**PETITION NO:** Z-31

**PROPOSED ZONING:** CRC, LI

**PROPOSED USE:** Retail, Self-Service  
Storage Facility

**PLANNING COMMENTS:**

# Z-31

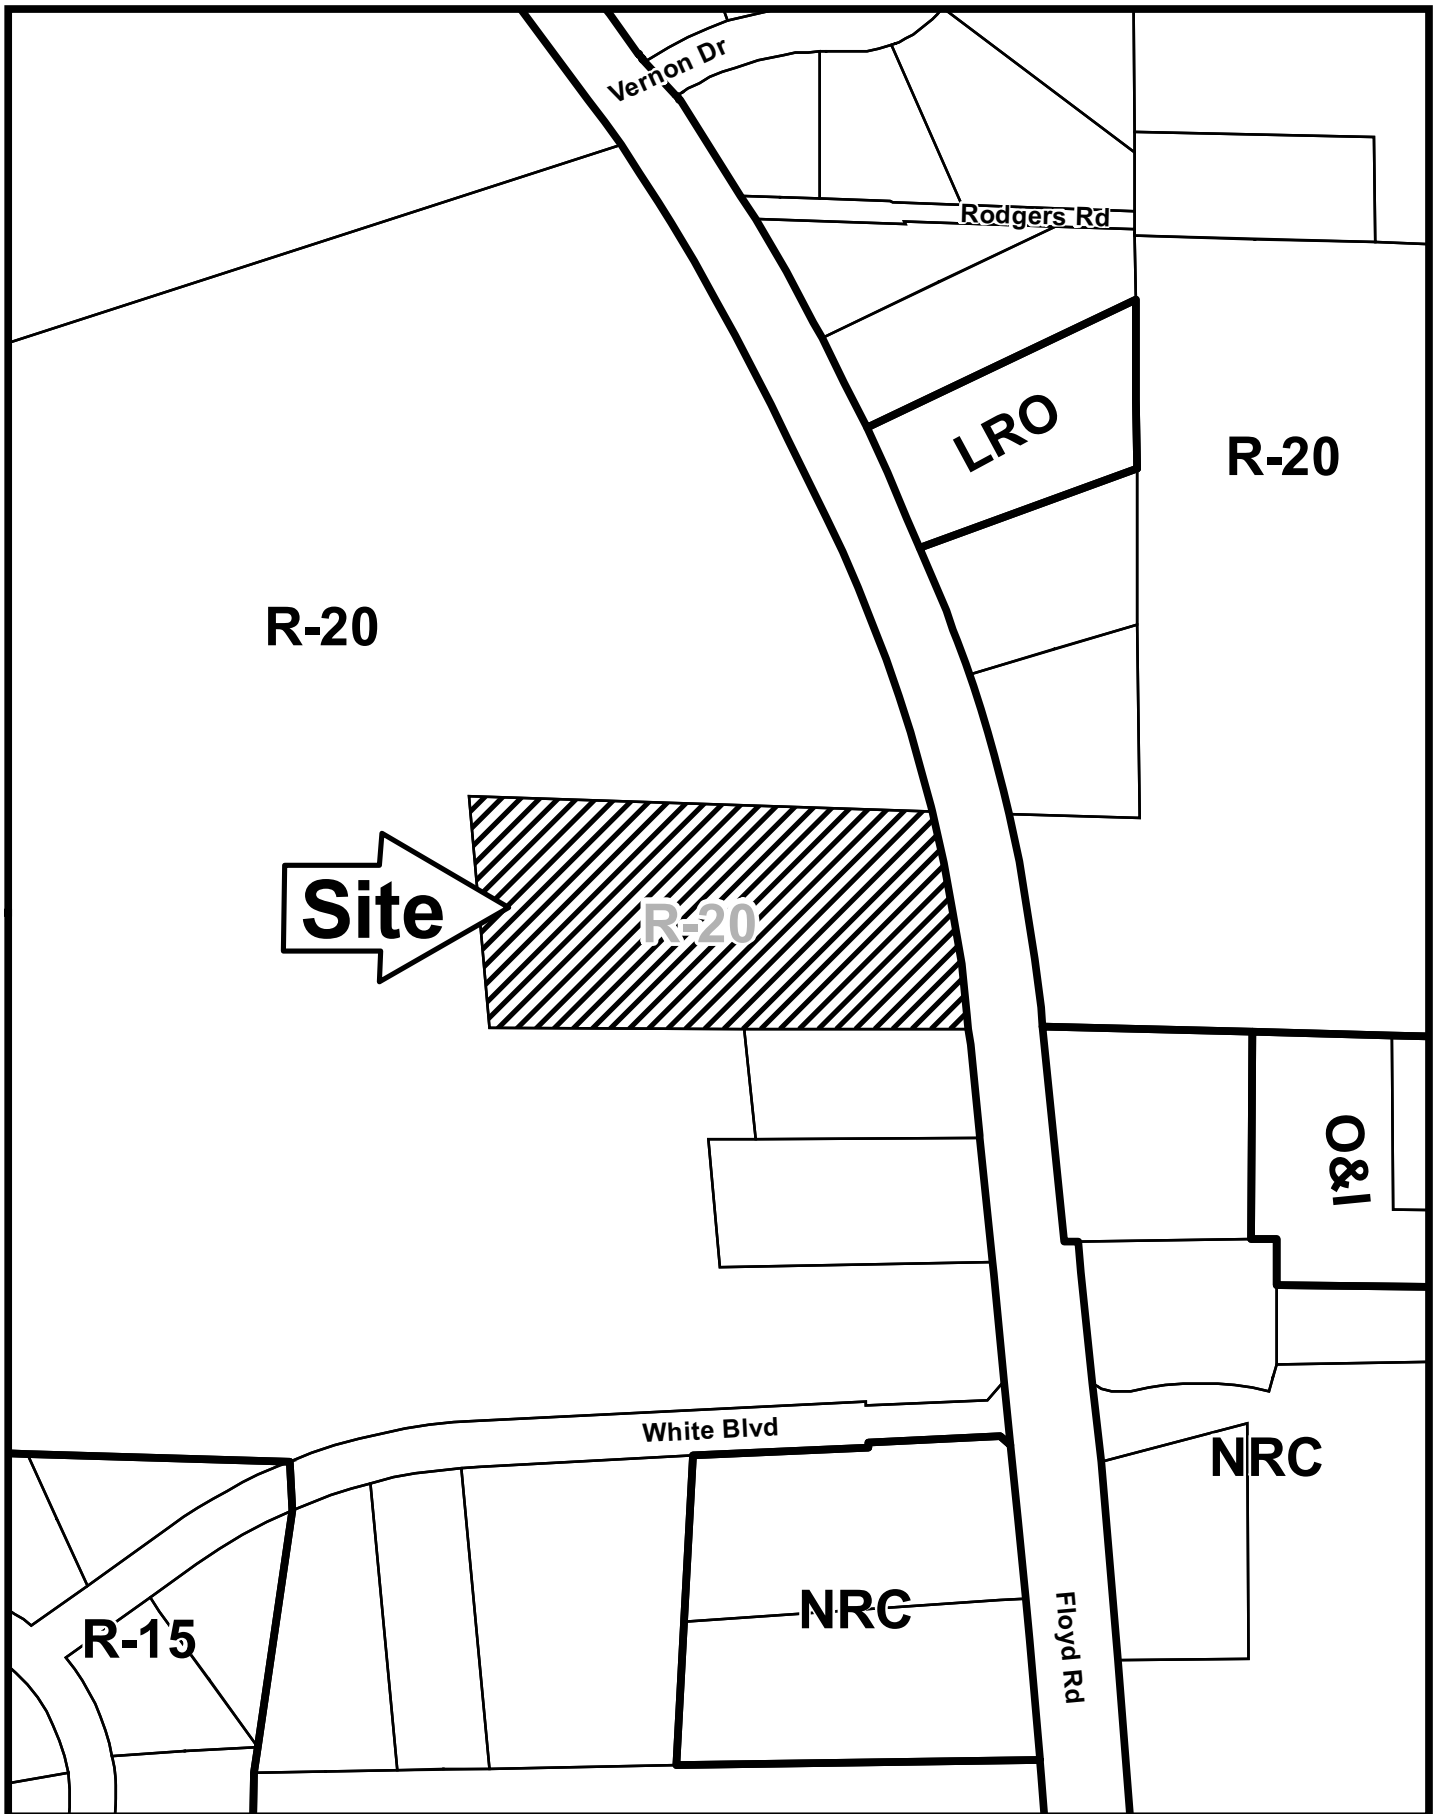
1. The proposed site plan exhibit shows the stormwater discharge being directed onto the adjacent residential parcel. Although this is the current flow path there is no well-defined conveyance to accept the increase in runoff volume that will be generated from the site – particularly from a concentrated discharge point. All stormwater runoff from the site will be required to be discharged directly into the existing 24-inch RCP storm system in the Floyd Road R/W. The allowable site discharge may be limited by the existing system capacity.

Align the proposed driveway with the opposing southern driveway for the school.

Recommend aligning the proposed driveway with the opposing school's driveway.
